# Response to Comments on the Periodic Monitoring Report for Vapor-Sampling Activities at Material Disposal Area L Fourth Quarter Fiscal Year 2011, Los Alamos National Laboratory, EPA ID No. NM0890010515, HWB-LANL-11-096, Dated December 2011

#### Certificate of analysis for the B&K check gas

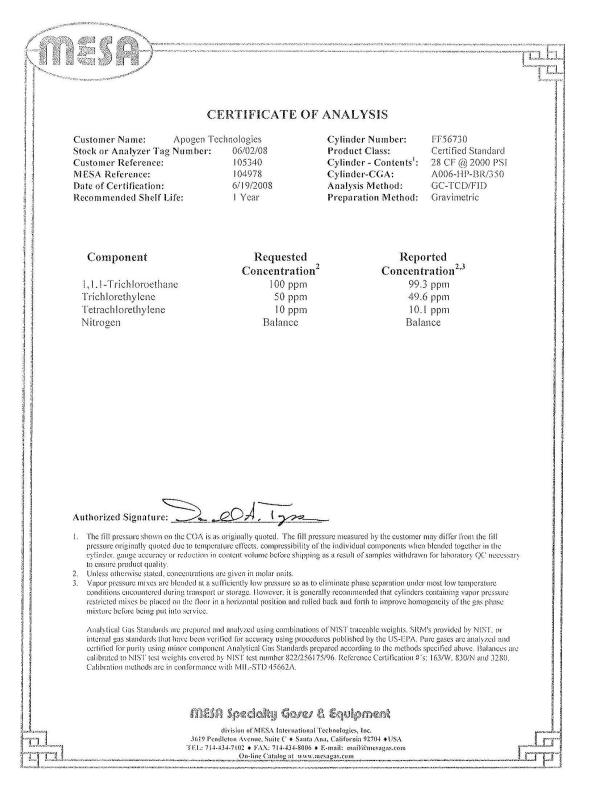
2. The text of Appendix B of the 2008 PMR states that the qualification was based on an "equipment blank". In the data validation narrative from LANL for this particular sample, LANL refers to the sample as the "PEB". There is no reference or definition as to what PEB stands for. Considering that there were such high concentrations of a specific set of constituents on the summa canister labeled "Client Sample ID: MD54-08-14683", is it possible that this was a sample of the span gas used for the B&K field instrument? Can you provide NMED with the specifications of the span gas utilized during the 4qFY2008 sampling event?

2. The Laboratory agrees with NMED that the "PEB" sample was a sample of the B&K check gas. The certificate of analysis for the check gas is included. As noted above, the Laboratory will change the detection status of the samples from borehole 54-24399 in the database.
